in the matter of: notices of requirement and resource consent applications by the NZ Transport Agency and Hamilton City Council for the Southern Links Project

Rebuttal evidence of David van Staden (*concept design philosophy*) on behalf of the **NZ Transport Agency and Hamilton City Council**

Dated: 8 July 2014

Southern Links
Peacocks North / South
Layout Plan and Long Section

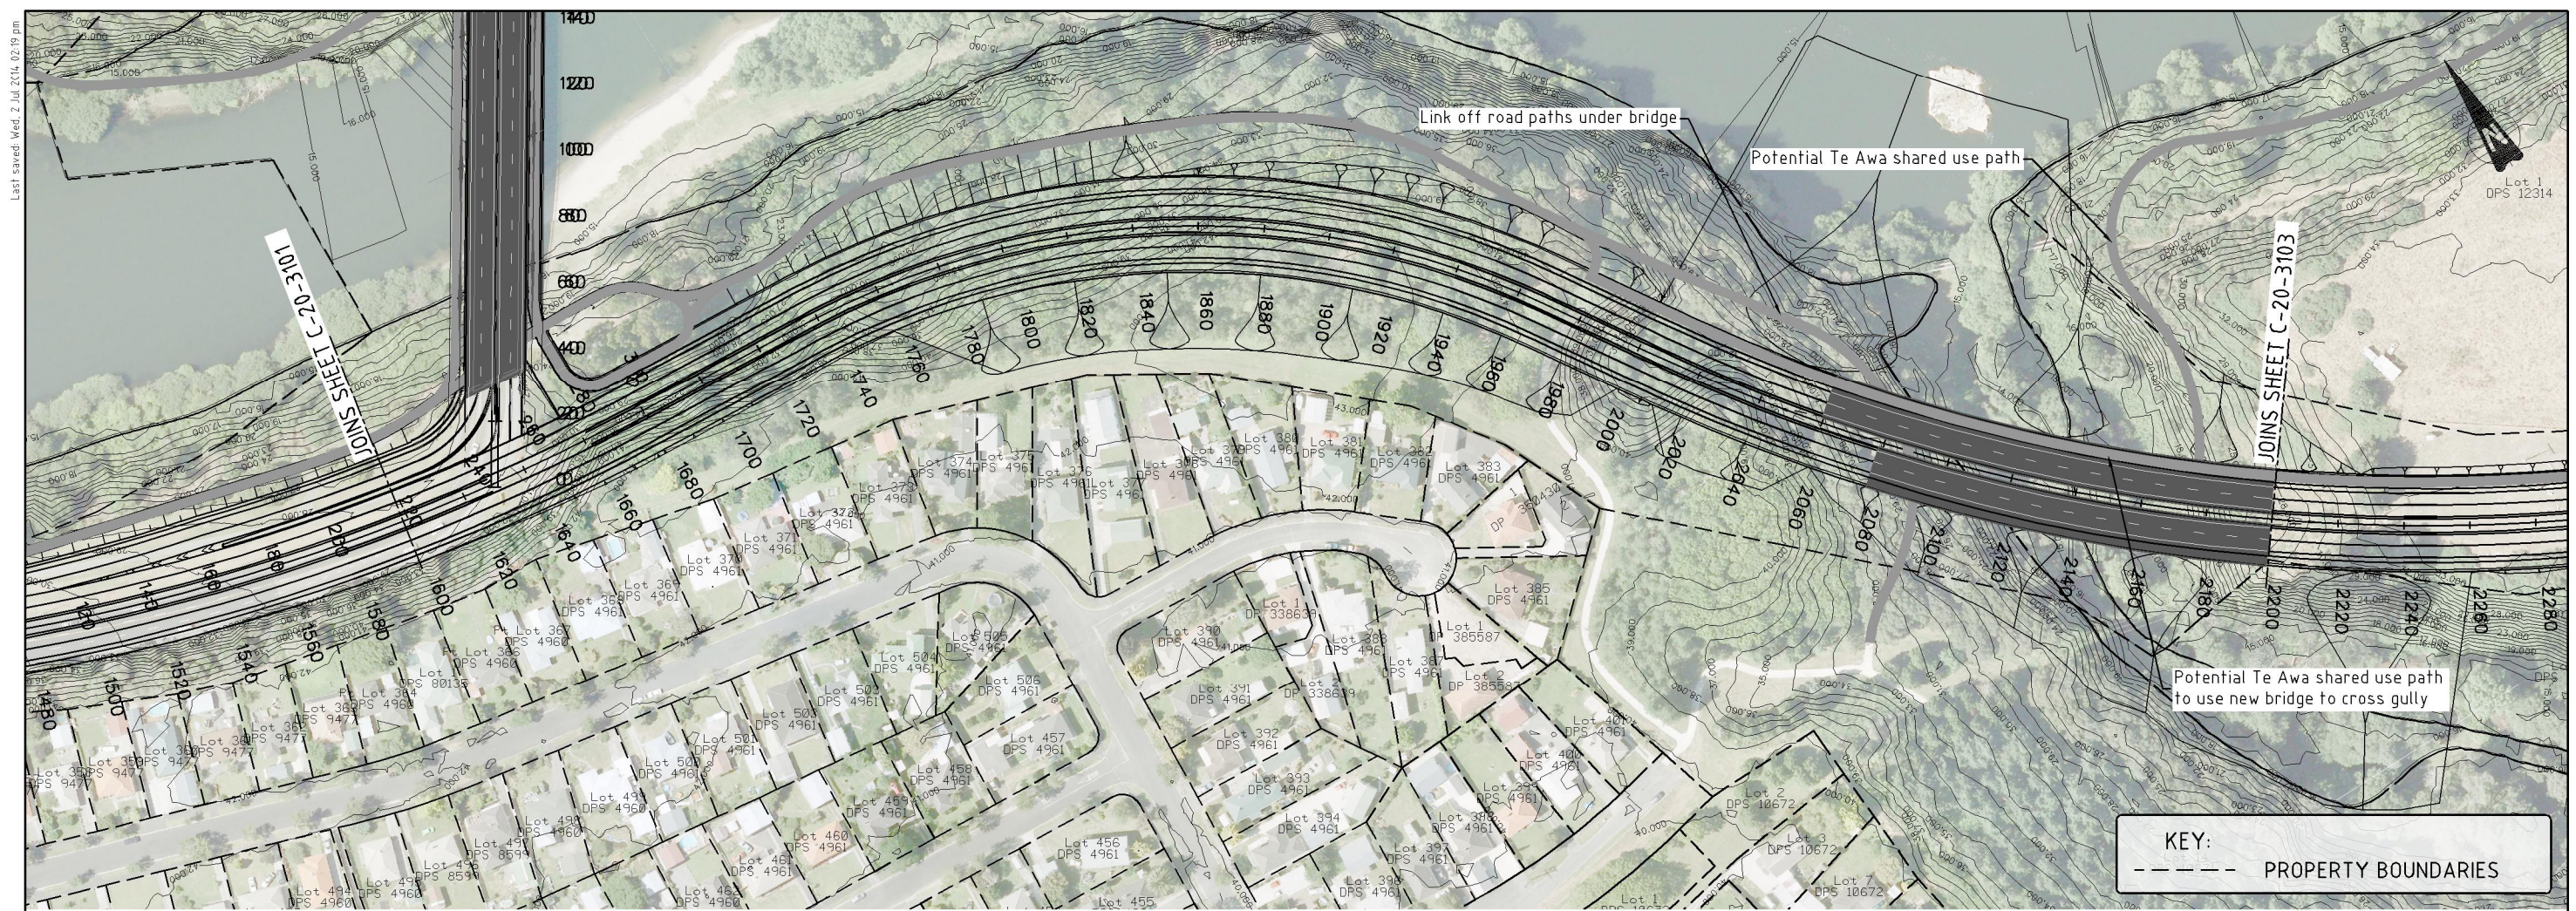
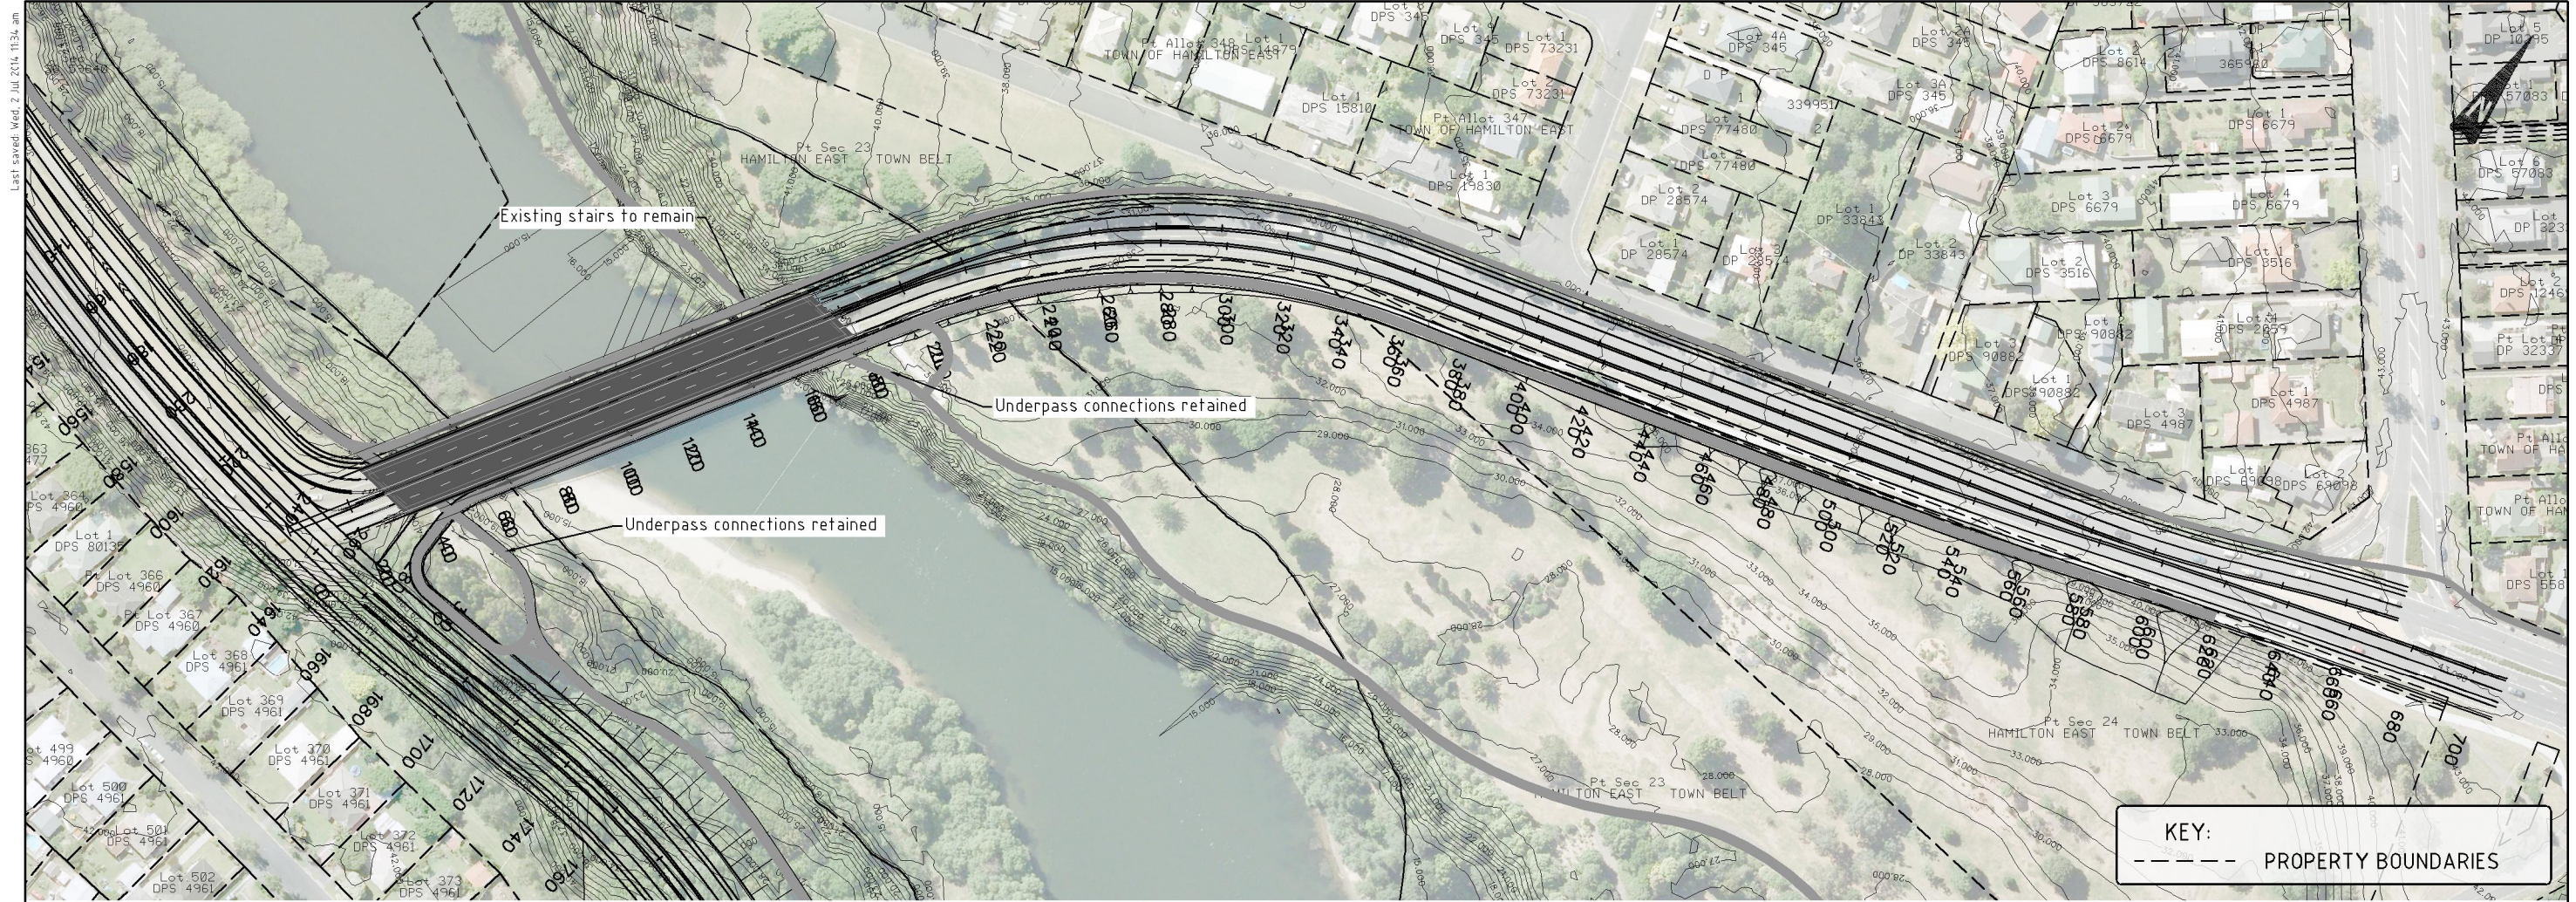
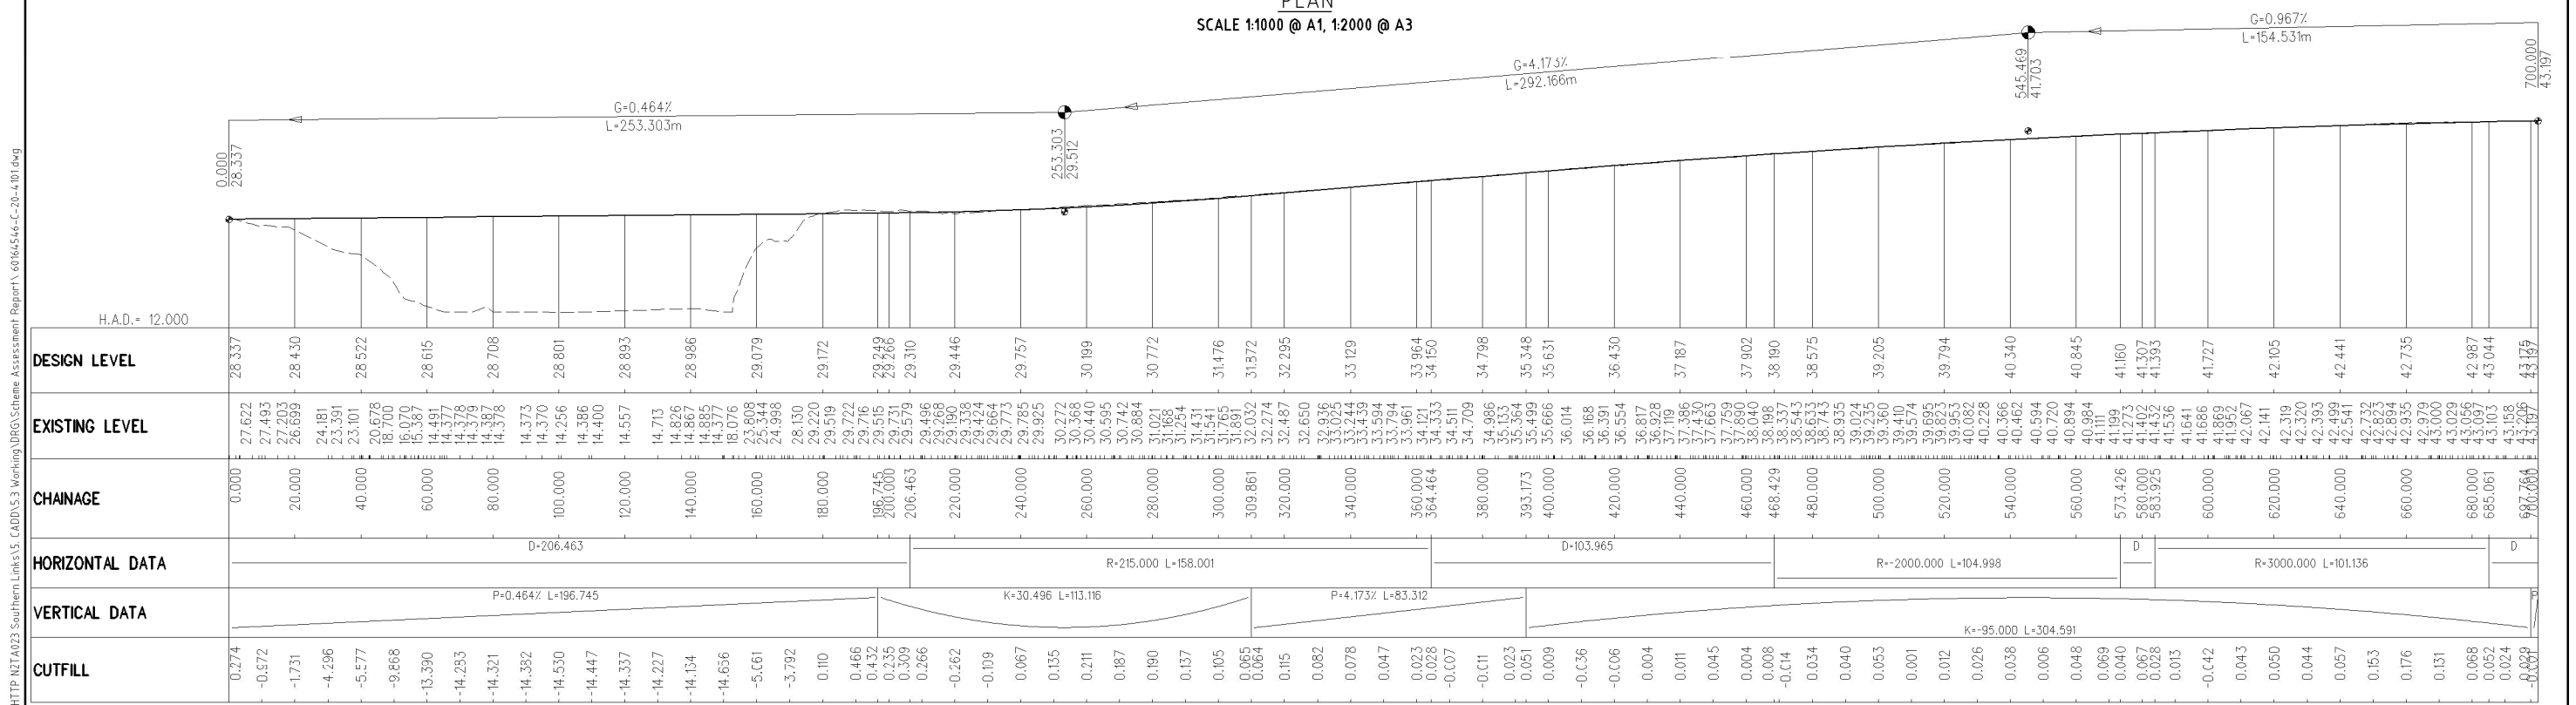
- 9 In accordance with Mr Ryan's suggestion¹, the applicable drawings around Cobham Bridge and the north end of the north-south Arterial have been updated to reflect the path layouts and connectivity depicted in Annexure B of my EIC. The updated drawings are attached in **Annexure A** of my Rebuttal Evidence. The updated drawings will be referred to in the Hamilton City Council's updated proposed conditions².
- 10 The Preliminary Design Philosophy Statement (*PDS*) has also been updated (in Section 9.2.1) to reflect the intentions for the path connections. The updated PDS is attached in **Annexure B** of my Rebuttal Evidence.
- 11 With the abovementioned additions to the drawings and the PDS, I do not believe a designation condition is necessary as has been requested by Mr Ryan³.

- 23 Mr Paul Ryan (on behalf of Hamilton City Council as Territorial Authority) requested more detail concerning path connections and underpasses around the Cobham Bridge. This detail is provided with in my Rebuttal Evidence. I do not believe an additional designation condition is required as requested by Mr Ryan.

No.	BY	DATE	DESCRIPTION	APPD.
C	KC	02.07.14	Shared use paths and notes added	DVS
B	KC	30.05.13	General Updates	DJM
A			For Information
